V2500 A5 SERIES PROPULSION SYSTEM SERVICE BULLETIN

This document transmits the Initial Issue of Service Bulletin EV2500-71-0294 and the Initial Issue of the Supplement

POWER PLANT – ELECTRICAL HARNESS – EEC HARNESS – FAN – DELETION OF LIGHTNING STRIKE
PROTECTION SLEEVES – MOD 71-0294

V2500-ENG-71-0294

Clipping point 1447 - Before and after modification
Fig.1

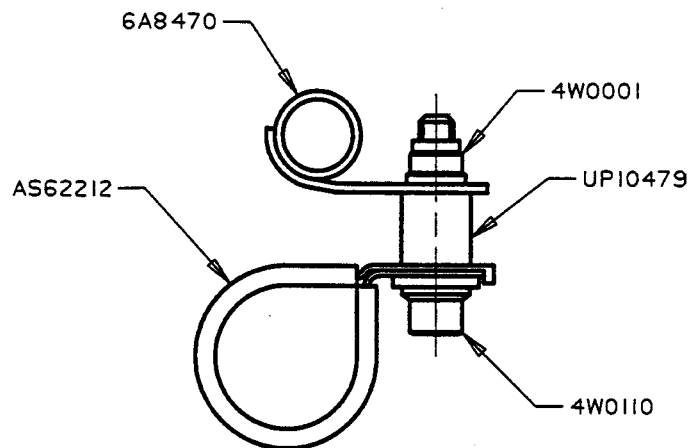
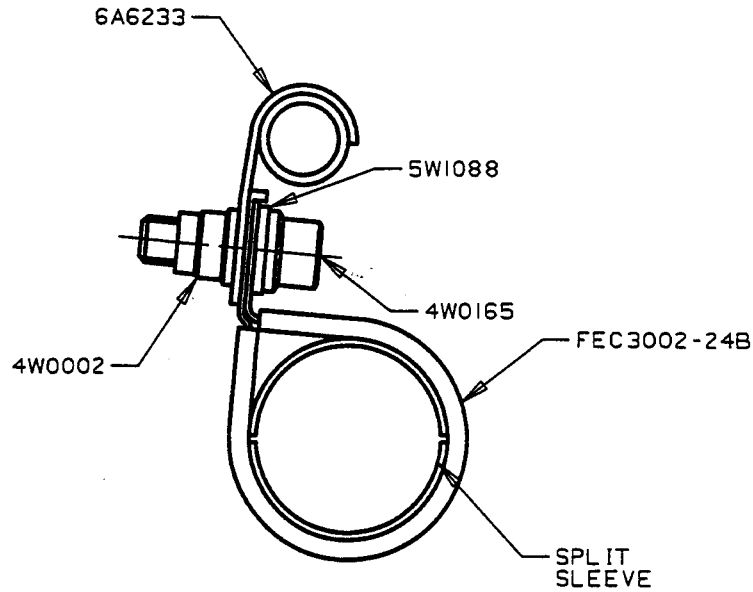
(c) The following clip points are revised: CP1447, CP1448, CP1449 and CP1450.

CLIPPING POINT 1447
PRIOR TO MODIFICATION

CLIPPING POINT 1447
AFTER MODIFICATION

Clipping point 1448 - Before and after modification
Fig.2

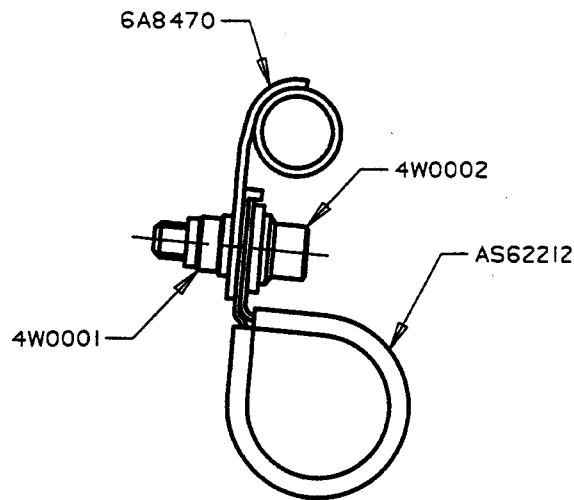
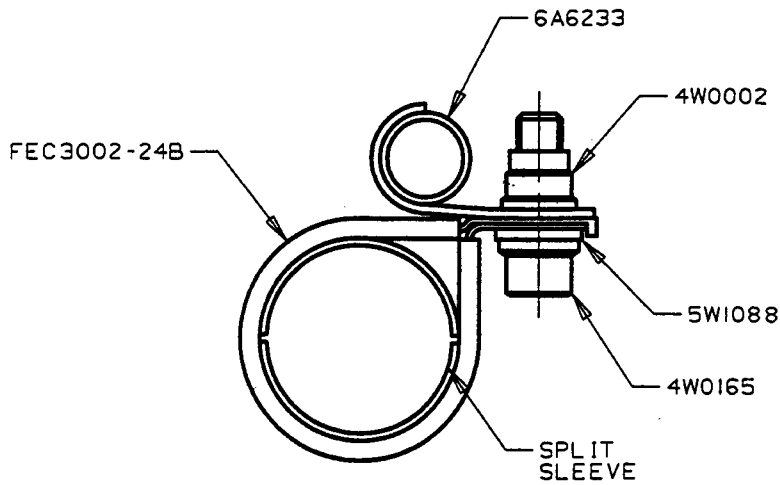
CLIPPING POINT 1448
PRIOR TO MODIFICATION

CLIPPING POINT 1448
AFTER MODIFICATION

Clipping point 1449 - Before and after modification
Fig.3

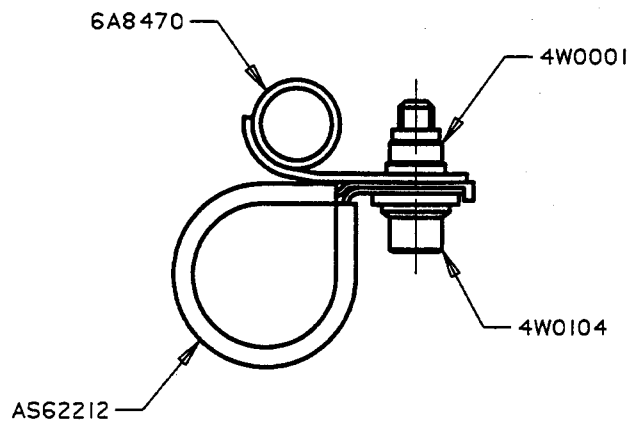
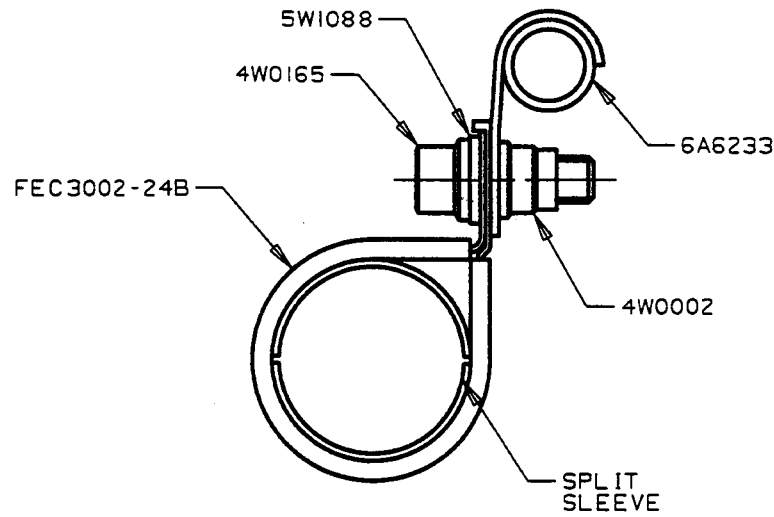
CLIPPING POINT 1449
PRIOR TO MODIFICATION

CLIPPING POINT 1449
AFTER MODIFICATION

Clipping point 1450 - Before and after modification
Fig.4

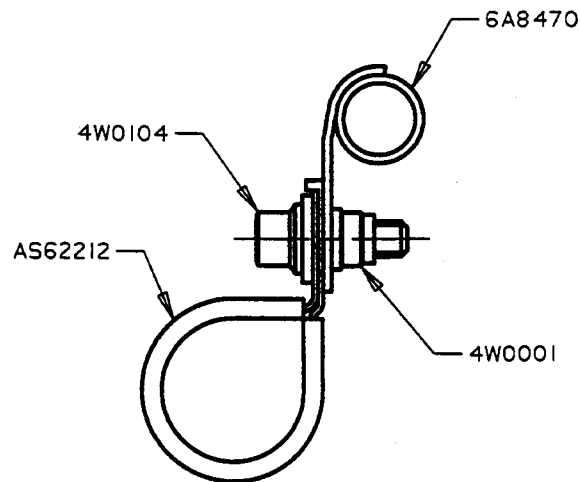
CLIPPING POINT 1450
PRIOR TO MODIFICATION

CLIPPING POINT 1450
AFTER MODIFICATION
